**NUCLEAR DIRECTORATE
GENERIC DESIGN ASSESSMENT – NEW CIVIL REACTOR BUILD**

**STEP 3 STRUCTURAL INTEGRITY ASSESSMENT OF THE WESTINGHOUSE AP1000
DIVISION 6 ASSESSMENT REPORT NO. AR 09/013-P**

EXECUTIVE SUMMARY

AP1000 RPV side elevation with various parts and welds identified. (Dimensions in inches)

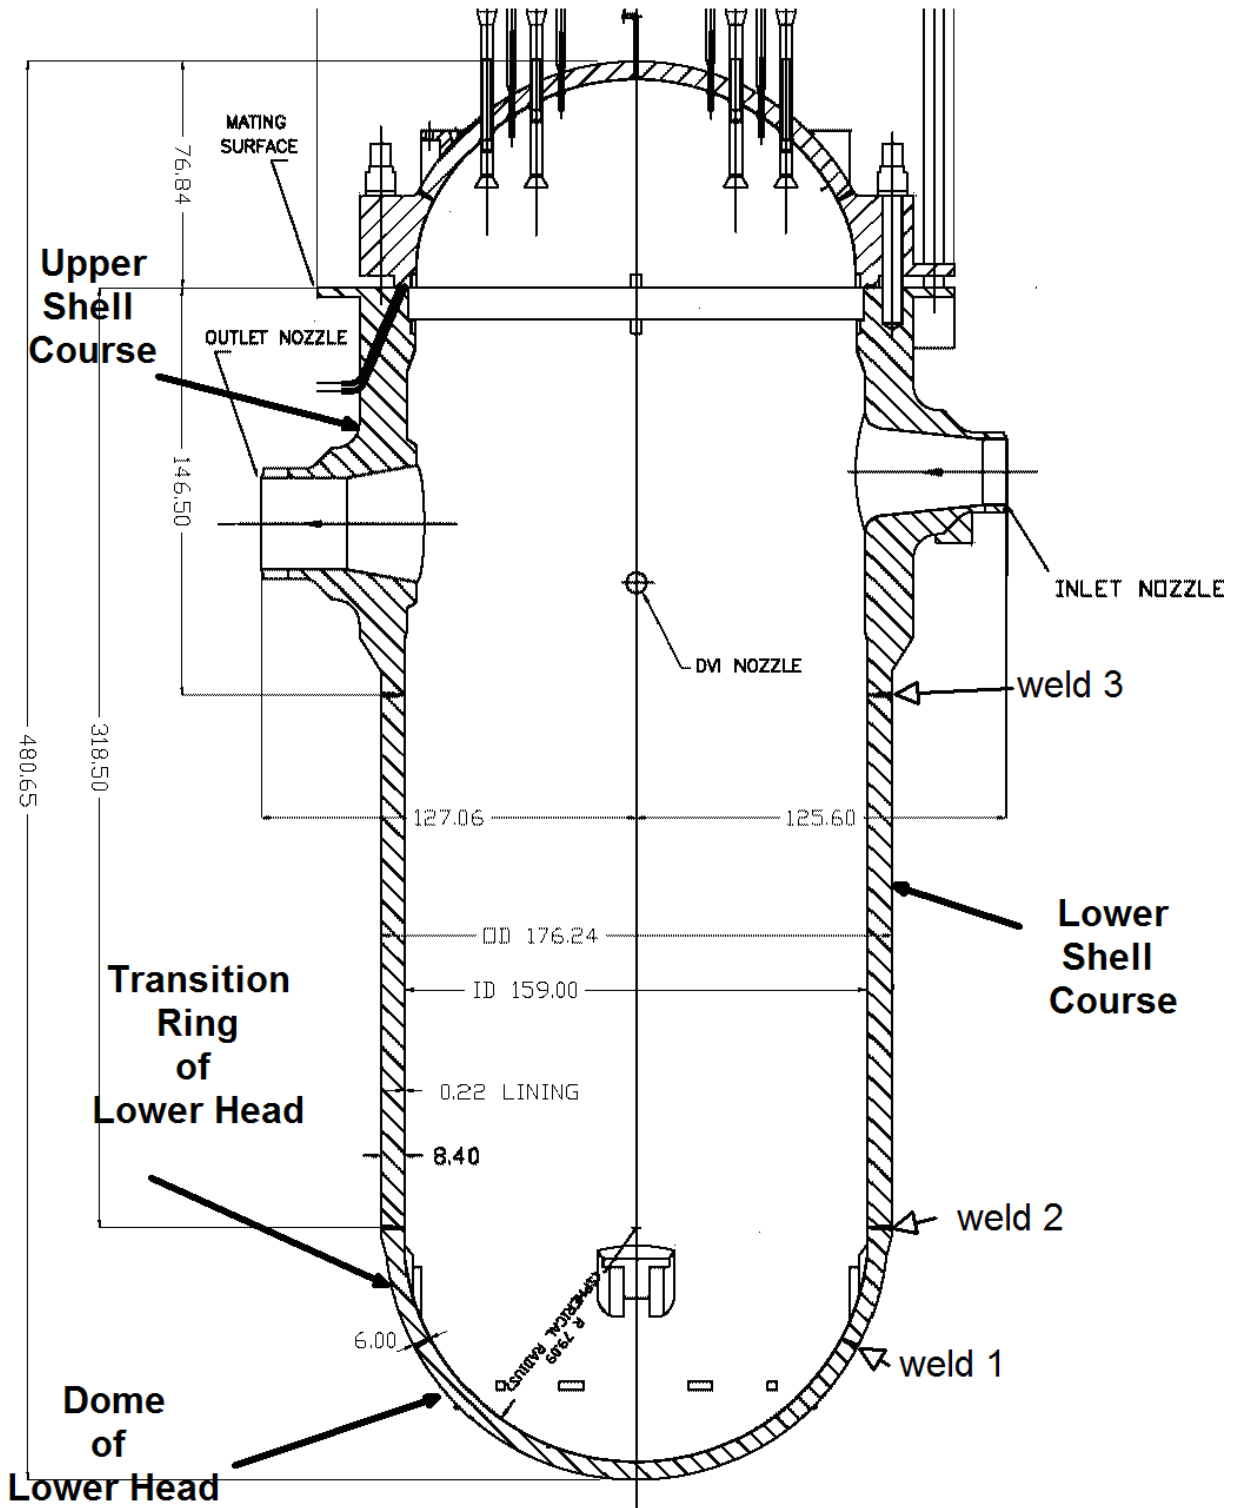
- 171 Paragraph 262 of the SAPs (Ref. 8) Item (c) states that designs should consider avoiding welds in high neutron radiation locations.
- 172 Figure 1 here shows the locations of three circumferential welds in the body of the Reactor Pressure Vessel, Welds 1, 2 and 3. These welds join the ring forgings identified as the Upper Shell Course, Lower Shell Course and Transition Ring of Lower Head; there are no axial welds in the reactor Pressure Vessel. Welds 2 and 3 receive significant neutron irradiation over the 60 year design life, that is higher than 1×10^{19} n/cm² (E>1MeV). Weld 1 receives a much lower dose over the 60 year life.

- 173 The peak neutron dose occurs about mid-way between Welds 2 and 3, at core mid-height. From Figure 1 it will be seen there is no weld between Welds 2 and 3. This means there is no weld at the location of peak neutron dose. Clearly this in part meets the SAPs expectation mentioned above. However, Welds 2 and 3 do receive a life time dose that

192 Westinghouse specifies the start of life RT_{NDT} as -23.3°C for “beltline forgings”, and -28.9°C for “beltline welds”. I have confirmed that “beltline forgings” means the Upper Shell Course, Lower Shell Course and Transition Ring of Lower Head (TRIM Ref. 2009/289088) and “beltline welds” are Welds 2 and 3, see Figure 1.

272 Regions of the RPV considered in setting P-T limits include the cylindrical region adjacent to the core (Lower Shell Course and Welds 2 and 3 in Figure 1).

Figure 1 AP-1000 RPV side elevation

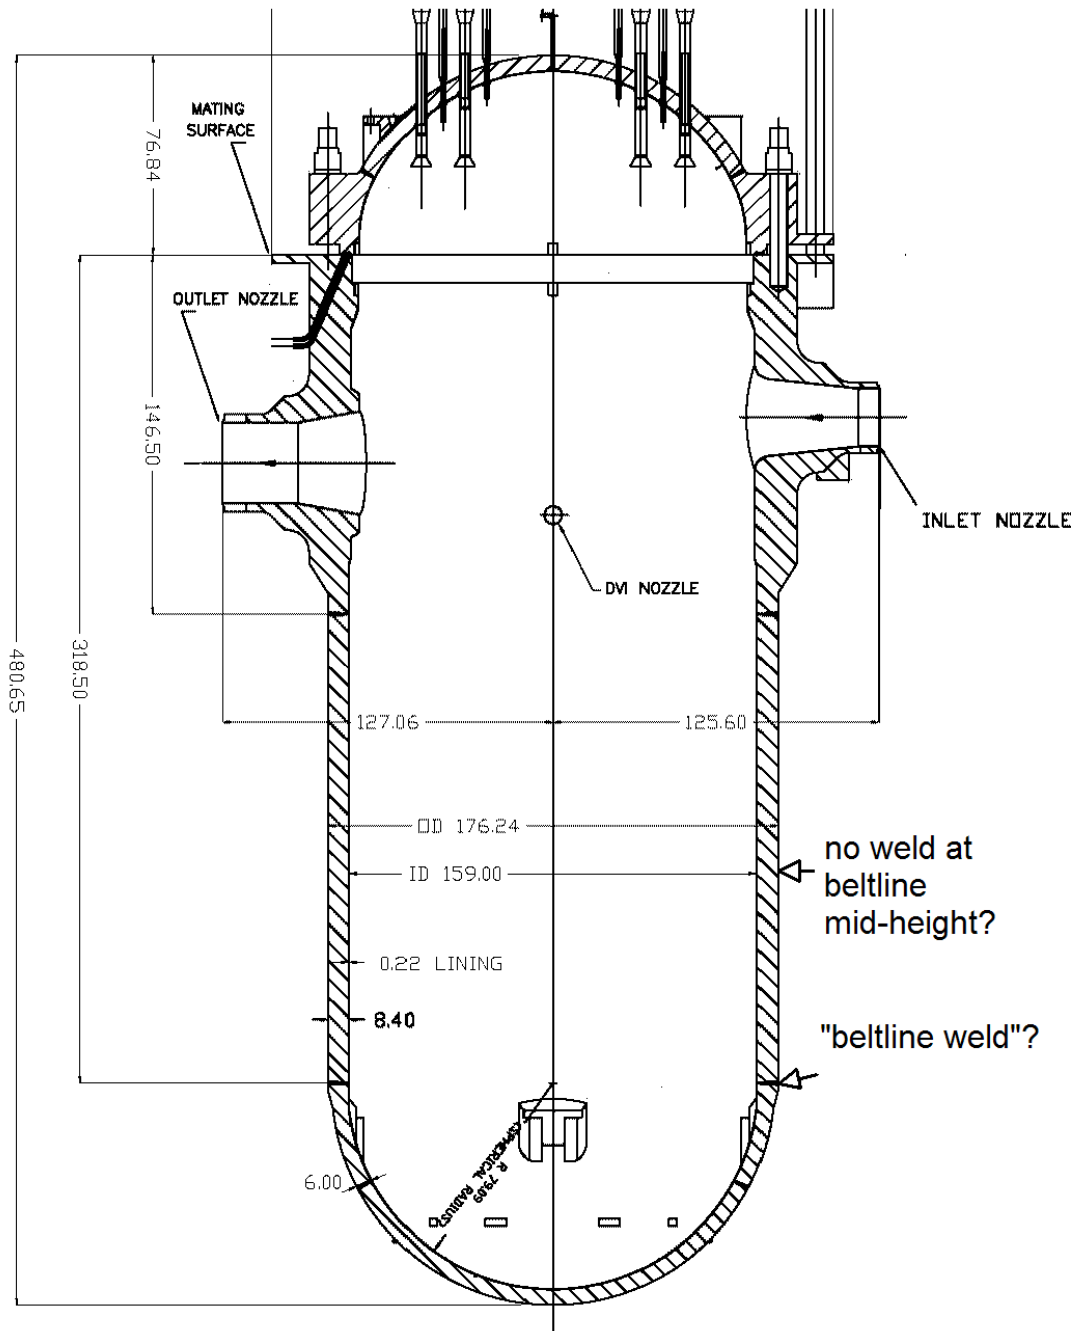
5-48, 5-50). Does reference to this weld mean the weld between the bottom of the shell course and the top of the lower head? And specifically, is there no circumferential weld at the beltline mid-height (see Figure 1)?

between bottom head dome and transition ring (Figure 1, weld 1);

between transition ring and bottom of the lower cylindrical ring (Figure 1, weld 2);

between top of upper cylindrical ring and bottom of nozzle shell / flange course (Figure 1, weld 3).

FIGURE 1 AP-1000 RPV side elevation with vessel body welds highlighted

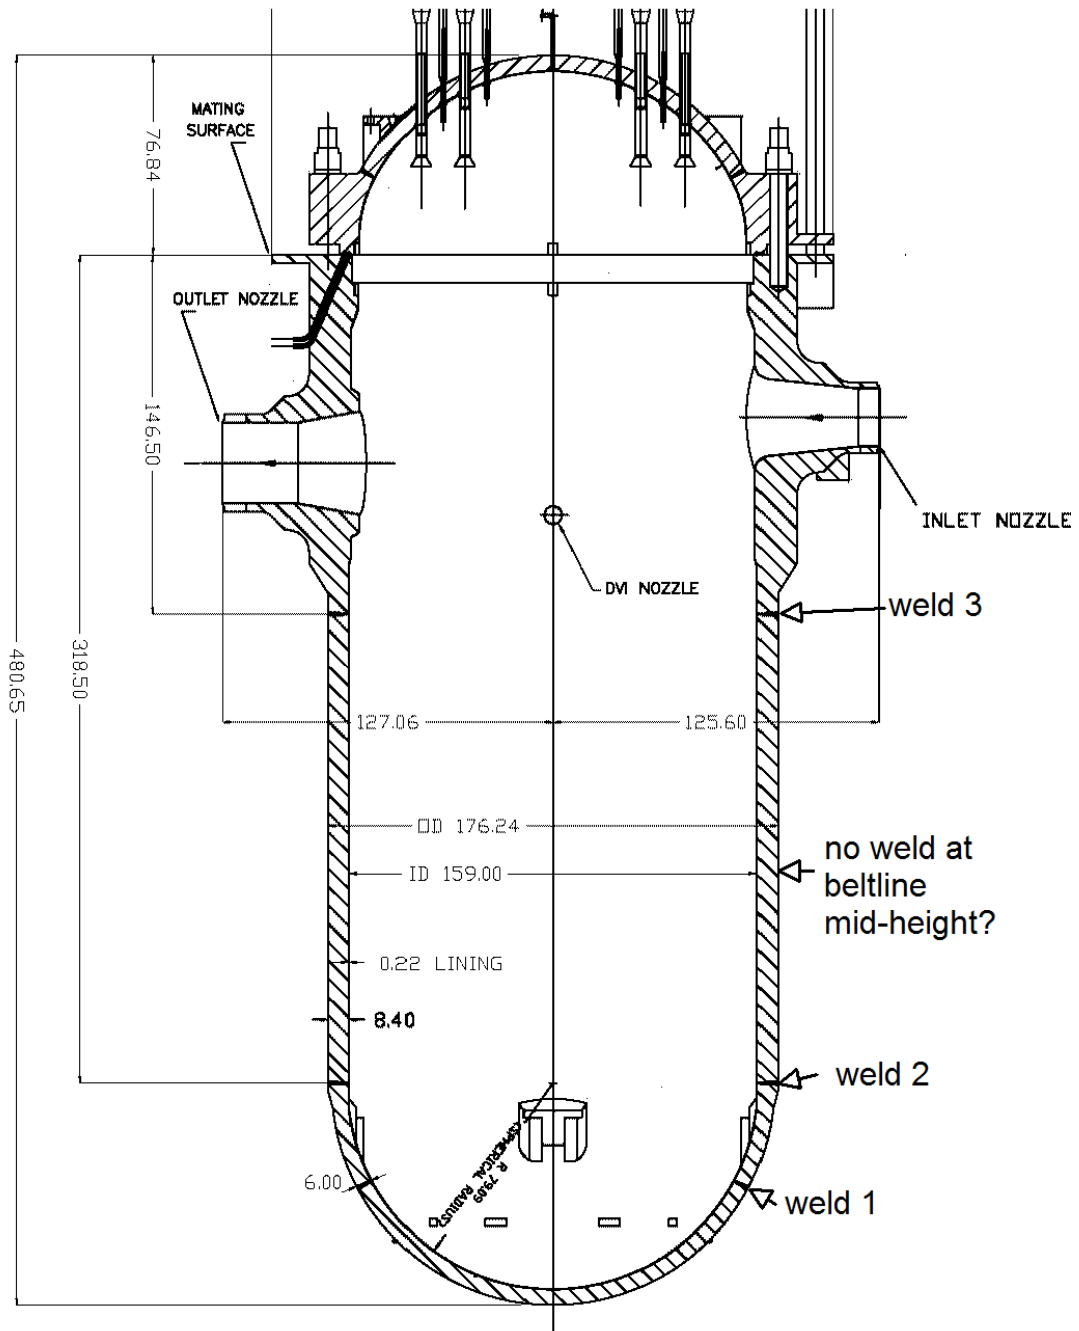
It appears that the RPV girth weld that receives the highest neutron fluence is the 'lower girth weld', weld 2 in Figure 1, also referred to in the UK AP-1000 documentation as the 'beltline weld'. The end of life (54 epy) neutron fluence to this weld is about 2.85×10^{19} n/cm² (E>1MeV). This differs from UK expectation for UK existing plant, where the weld subjected to the highest neutron fluence is the weld at the top of the cylinder, weld 3 in Figure 1. UK expectation for existing UK plant is the weld equivalent to weld 2 in Figure 2 will be receive a relatively low neutron dose by end of life.

What is the explanation for the AP-1000 weld 2 in Figure 1 being subjected to a higher neutron dose than weld 3? We note the length of the AP-1000 fuel assemblies (and therefore the core) is the same as a typical 'XL' fuel assembly (UK-GW-GL-700 Rev 2 Table 4.1-1 Sheet 4 of 4). Does this increased length for XL fuel compared with non-XL fuel mean the active region of the core extends lower down in the RPV, and so weld 2 is not shielded to the same extent with XL length fuel compared with shorter fuel?

For AP-1000, what is the anticipated end of life neutron fluence to the weld at the top of the cylindrical region of the RPV cylinder region, i.e. weld 3 in Figure 1?

weld 2 of Figure 1;

weld 3 of Figure 1.
